STATE OF NEW MEXICO
ENERGY AND MINERALS DEPARTMENT
OIL CONSERVATION DIVISION
AZTEC DISTRICT OFFICE

May 1, 1984

Re: Application for Hardship Classifications
Federal Com #2E P-11-28N-13W

APPLICATION FOR CLASSIFICATION AS HARDSHIP GAS WELL

#2E Fed. Com.

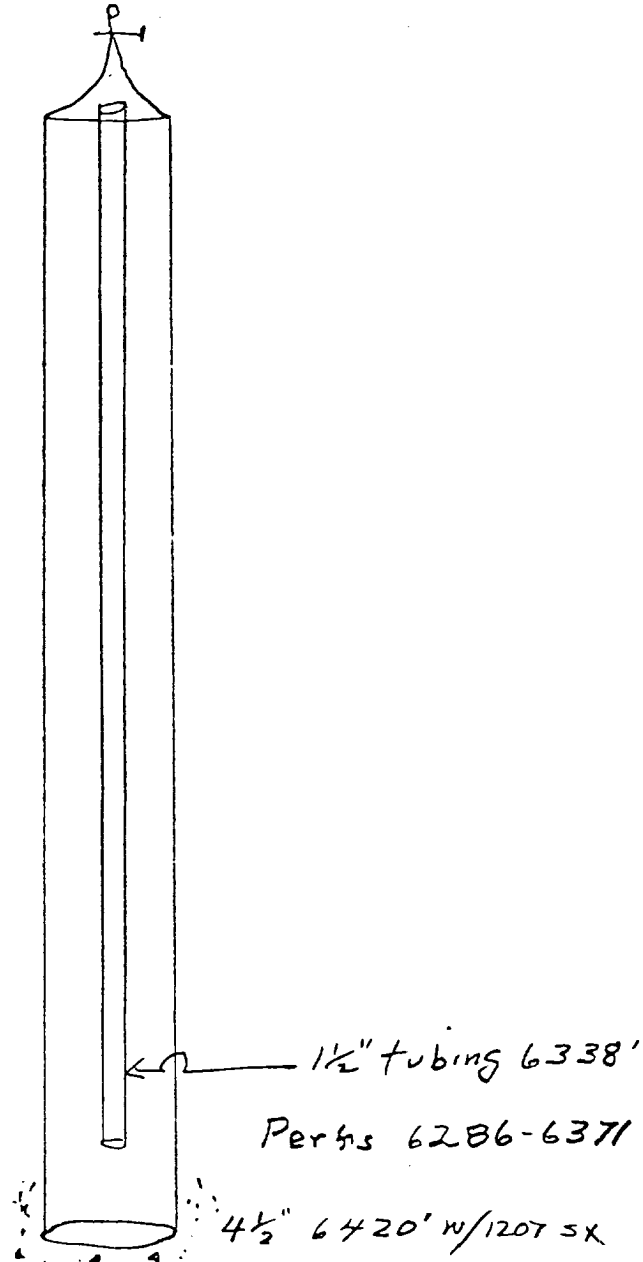
- 1) Venting a small amount of gas during swabbing is necessary as part of any swabbing operation, and does not necessarily constitute inefficient and dissipating use of reservoir energy as the energy is used to lift accumulated liquid.
- 2) There is no showing that extended shut-in decreases the ultimate recovery of the well.
- 3) You state that the well needed to be unloaded four times, but do not show how these "log offs" on a time line with production or state why the wells were shut in.
- 4) You did not show cost figures which indicate that without relief this well would be prematurely abandoned.
- 5) There is no calculation of reserves which would be lost due to premature abandonment.
- 6) There is no documentation of the well's production history. (log of production vs time, etc.)

You stated that the well would log-off if shut-in for "a month or more". Would a shut-in of two weeks be detrimental?
